# Urgent Field Safety Notice

Regarding **ProteusPLUS**

GENERAL INFORMATION	
<b>SUBJECT</b>	Potential range effect due to non-conformity of degrader graphite block 8.
<b>IBA REFERENCE</b>	Problem Report PR-58816
INFORMATION ON AFFECTED DEVICE(S)	
<b>PRODUCT</b>	Proteus 235
<b>BRAND NAME</b>	ProteusPLUS
<b>COMPONENT</b>	Beam Management System
<b>SOFTWARE VERSIONS</b>	N/A
<b>MODE</b>	All
<b>SERIAL NUMBER</b>	SAT.115, SAT.116
REASON FOR FIELD SAFETY NOTICE	
<b>DESCRIPTION OF THE PRODUCT PROBLEM</b>	IBA discovered that the holes for the screw inserts to attach the graphite block 8 to the degrader wheel are too deep. See Annex 1 for a schematic description and x-ray image of the non-conformity. As a result of the non-conformity, the beam could go through an air pocket due to the excess depth of the screw hole instead of graphite leading to range errors and the potential mistreatment of a patient. The graphite block 8 is only used for high ranges (see Annex 2 for detailed values).

## Annex 1 Graphite block 8 screw holes depth non-conformity

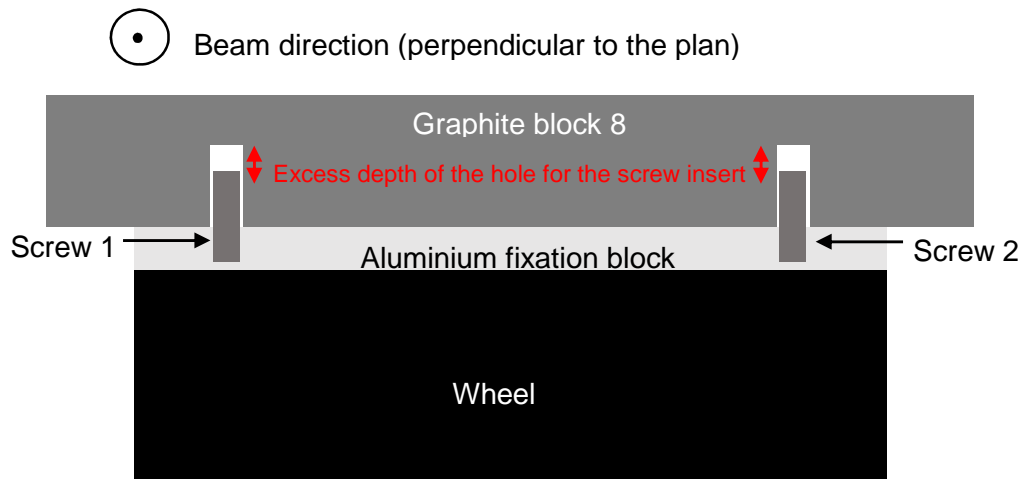
Schematic description of the graphite block 8 screw holes depth non-conformity:
